SUBJECT: VIRGIL C. SUMMER NUCLEAR STATION, UNIT 1 - STAFF ASSESSMENT OF INFORMATION PROVIDED PURSUANT TO TITLE 10 OF THE *CODE OF FEDERAL REGULATIONS* PART 50, SECTION 50.54(f), SEISMIC HAZARD REEVALUATIONS RELATING TO RECOMMENDATION 2.1 OF THE NEAR-TERM TASK FORCE REVIEW OF INSIGHTS FROM THE FUKUSHIMA DAI-ICHI ACCIDENT (TAC NO. MF3831)

STAFF ASSESSMENT BY THE OFFICE OF NUCLEAR REACTOR REGULATION

RELATED TO SEISMIC HAZARD AND SCREENING REPORT

VIRGIL C. SUMMER NUCLEAR STATION, UNIT 1

**Figure 3.2-1 Plot Comparing the Staff's and the Licensee's Mean Control Point Hazard Curves at a Variety of Frequencies. RAI Response Curves are Licensee Curves Developed Using the Currently Endorsed CEUS-SSC for the VCSNS site**

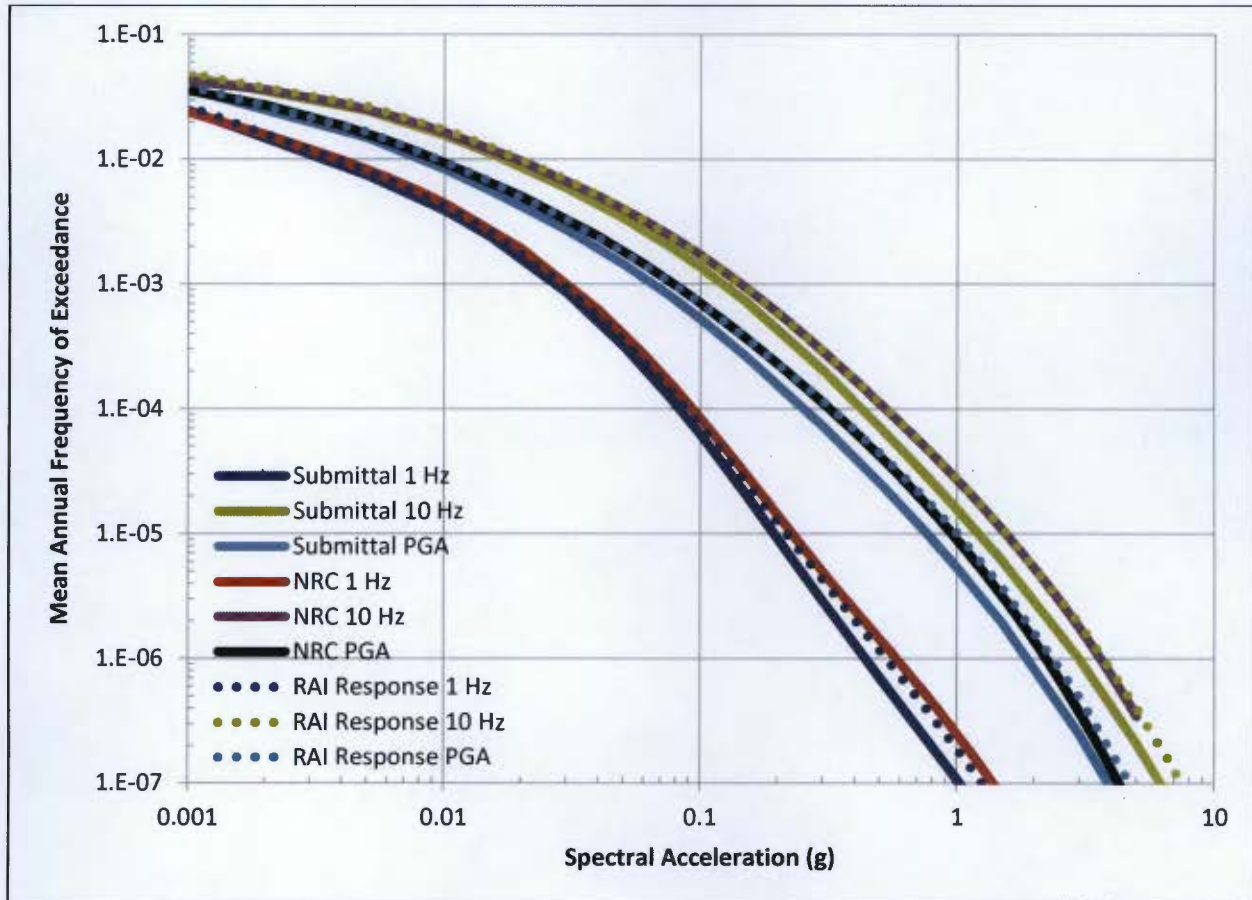
Figure 3.2-1 of this assessment shows the hazard curves developed by the licensee using the modified CEUS-SSC, the hazard curves developed by the licensee using the original CEUS-SSC, and the hazard curves developed by the NRC staff for three of the seven spectral frequencies. The hazard curves developed by the licensee using the original CEUS-SSC model without the catalog revisions are, as expected, the same as the curves developed by the NRC staff. The hazard curves developed by the licensee using the modified CEUS-SSC are consistently lower than those developed using the original CEUS-SSC by about 6 to 16 percent, which indicates that the licensee's revisions to the catalog for the southeastern U.S. had a modest but not insignificant impact.

**Figure 3.4-1 Comparison of the Staff's GMRS with Licensee's GMRS and the SSE for the VCSNS site**

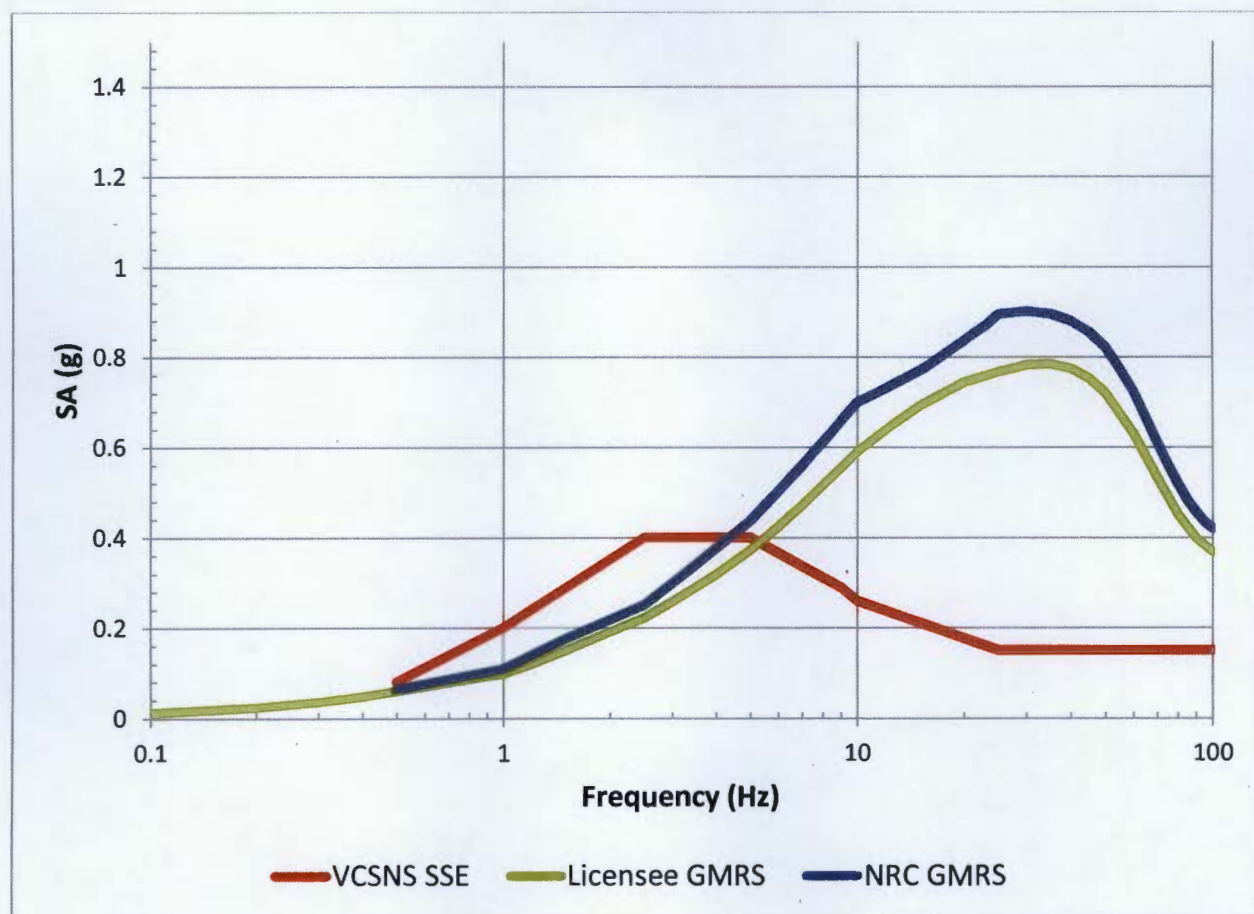
The NRC staff independently calculated the  $10^{-4}$  and  $10^{-5}$  UHRs using the results of its confirmatory PSHA, as described in Section 3.2 of this staff assessment. Figure 3.4-1 of this assessment shows a comparison of the GMRS determined by the licensee to that determined by the NRC staff.

As shown in Figure 3.4-1, the licensee's GMRS shape is generally similar to that calculated by the NRC staff at all frequencies. However, the NRC staff's confirmatory GMRS is slightly higher than the licensee's. As described in Section 3.2, the NRC staff concludes that these differences are due to changes the licensee made to the published CEUS-SSC catalog when conducting the PSHA.

Based on the NRC staff's review of the licensee's SHSR, RAI response and SSHAC report, the staff confirms that the licensee used the present-day guidance and methodology outline in RG 1.208 and the SPID to calculate the horizontal GMRS, as requested in the 50.54(f) letter. The NRC staff performed a PSHA confirmatory analysis and achieved results consistent with the licensee's base rock hazard curves developed with the CEUS-SSC as published. As such, the NRC staff concludes that the GMRS determined by the licensee adequately characterizes the reevaluated hazard for the VCSNS site for the purposes of screening. Because the NRC staff accepted the licensee's SSHAC Level 2 study justifying modifications for the limited purpose of response to the 50.54(f) letter, the staff concludes that the GMRS determined by the licensee adequately characterizes the reevaluated hazard for the VCSNS site. Therefore, this
